# VALUE ENGINEERING STUDY REPORT

Interstate 25 – Managed Lanes  
US 36 to 120<sup>th</sup> Avenue

Value Engineering Study  
14 – 17 January 2013

RE: Value Engineering Study Report  
I-25 Managed Lanes: US 36 to 120<sup>th</sup> Avenue  
Colorado DOT Project Code No. 18695

<b>VALUE ANALYSIS DESIGN ALTERNATIVE</b>		ALTERNATIVE NO.:
PROJECT:	<b>I-25 Managed Lanes: US 36 to 120<sup>th</sup> Ave</b> <b>IM 0253-222      PCN 18695</b>	<b>PV-8</b>
DESCRIPTION:	<b>ON SB I-25, PROVIDE PARALLEL ACCELERATION LANE</b> <b>FROM 104<sup>TH</sup> AVE</b>	SHEET NO.: 1 of 5

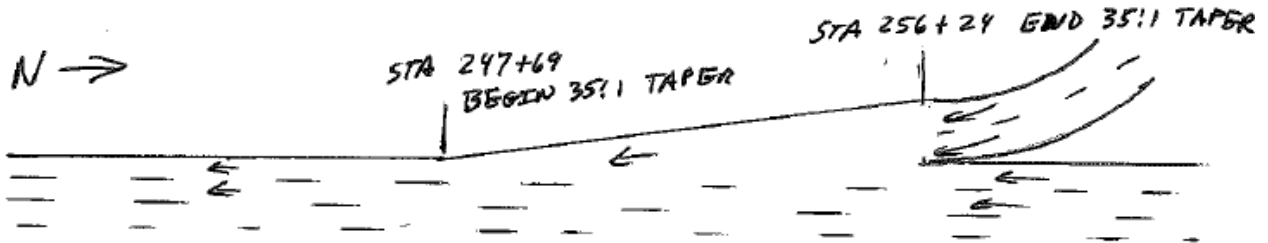
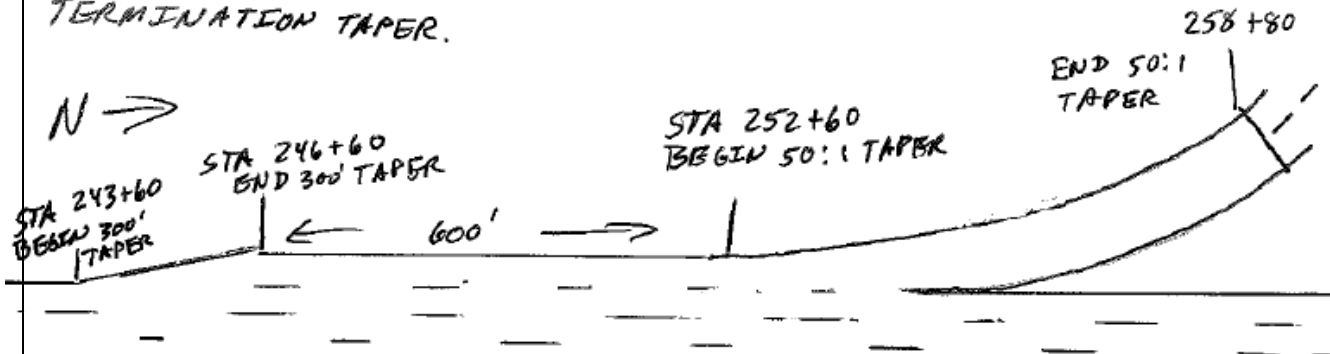
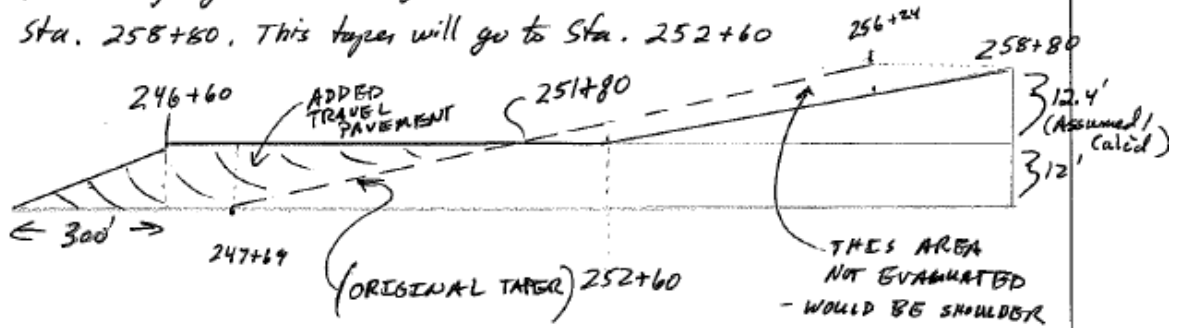
Provide a 50:1 (620ft) taper to merge two on-ramp lanes onto one, then provide a 600ft parallel acceleration lane, terminating with a 300ft lane termination taper.

The taper and parallel accelerations lengths are regularly used in the metro area and are consistent with AASHTO guidance.

SIMPLE TAPER 35:1 (855') TO MERGE TWO ON-RAMP LANES ONTO I-25

STARTING AT RAMP METER, @ ~ STA 258+80, USE 50:1 (620') TAPER TO MERGE TWO ON-RAMP LANES TO ONE LANE. THEN, PROVIDE 600' PARALLEL ACCEL LANE, FOLLOWED BY 300' TERMINATION TAPER.

Start Merging Two On-Ramp Lanes @ Ramp Meter Stop-Bar @ Sta. 258+80. This taper will go to Sta. 252+60

<b>VALUE ANALYSIS DESIGN ALTERNATIVE</b>		ALTERNATIVE NO.:
PROJECT:	<b>I-25 Managed Lanes: US 36 to 120<sup>th</sup> Ave</b> <b>IM 0253-222      PCN 18695</b>	<b>PV-9</b>
DESCRIPTION:	<b>PROVIDE PARALLEL DECELERATION LANE – 1000’ APPROACH TO THORNTON PARKWAY</b>	SHEET NO.: 1 of 4

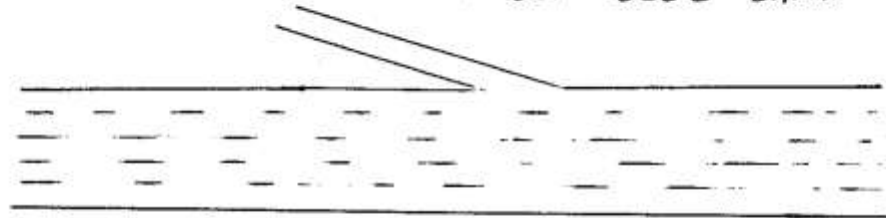
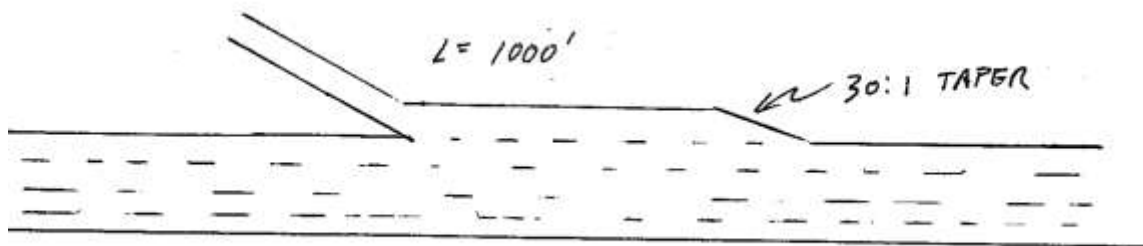
The alternative would provide a 1000’ deceleration lane prior to the off-ramp entrance. (See attached illustration)

There would be some significant advantages realized from adding this highly beneficial deceleration lane. First, the vehicles exiting the mainline to take the Thornton Road off-ramp will be able to more safely execute the maneuver. Since they will be able to move out of the mainline flow of traffic in order to decelerate, this added lane should assist in maintaining the flow of traffic on the mainline.

CONSTRUCT PARALLEL DECELERATION LANE  
500' MIN, 1000' PREFERRED

THE DECEL LANE COULD HELP WITH OVERALL OPERATION OF FACILITY.

<b>VALUE ANALYSIS DESIGN ALTERNATIVE</b>		ALTERNATIVE NO.:
PROJECT:	<b>I-25 Managed Lanes: US 36 to 120<sup>th</sup> Ave IM 0253-222      PCN 18695</b>	<b>PV-9A</b>
DESCRIPTION:	<b>PROVIDE 500 FOOT PARALLEL DECELERATION LANE FOR THE APPROACH TO THORNTON PARKWAY</b>	SHEET NO.: 1 of 4

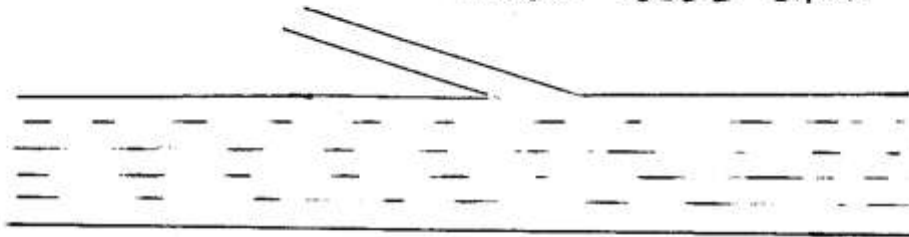
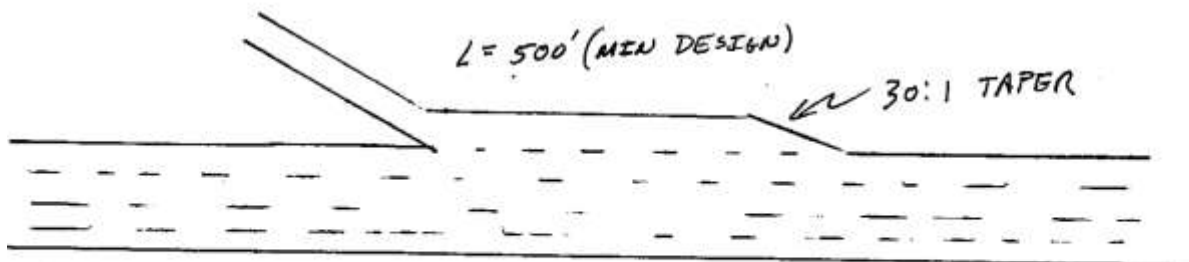
The alternative would provide a 500' (preferred design length) deceleration lane prior to the off-ramp entrance. (See attached illustration)

There would be some significant advantages realized from adding this highly beneficial deceleration lane. First, the vehicles exiting the mainline to take the Thornton Road off-ramp will be able to more safely execute the maneuver. Since they will be able to move out of the mainline flow of traffic in order to decelerate, this added lane should assist in maintaining the flow of traffic on the mainline.

CONSTRUCT PARALLEL DECELERATION LANE  
 500' MIN, 1000' PREFERRED

THE DECEL LANE COULD HELP WITH OVERALL OPERATION OF FACILITY.
